MODIFICATION SHEET NO ELRS/MS/0264

Modification in the 'Passenger Emergency Alarm Indication' circuit to prevent its operation during normal brake application through 'A9' by the driver.

MODIFIED ARRANGEMENT SHOWING ARRANGEMENT OF RGPA PRESSURE SWITCH

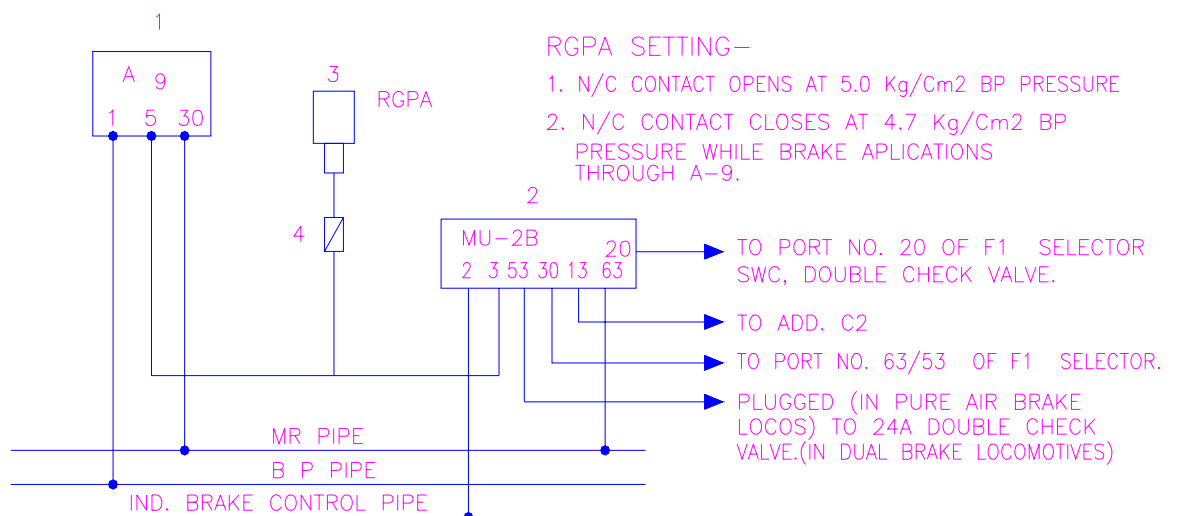
- (i) Passenger emergency alarm indication circuit is to be modified as per details given in Annexure-I & II.
- (ii) All drivers are to be instructed as follows.

1. AUTOMATIC BRAKE VALVE (A .9)
2. MU-28 VALVE.
3. PRESSURE SWITCH.
4. STRAINER (3/8")

RGAF SETTING:-

- (i) CUT-IN 4 Kg/cm²
- (ii) CUT-OUT 3.5 Kg/cm²

RGPA SETTING:-

- (i) N/C CONTACT CLOSSES AT - 4.7 Kg/cm²
- (ii) N/C CONTACT OPENS AT - 5.0 Kg/cm²
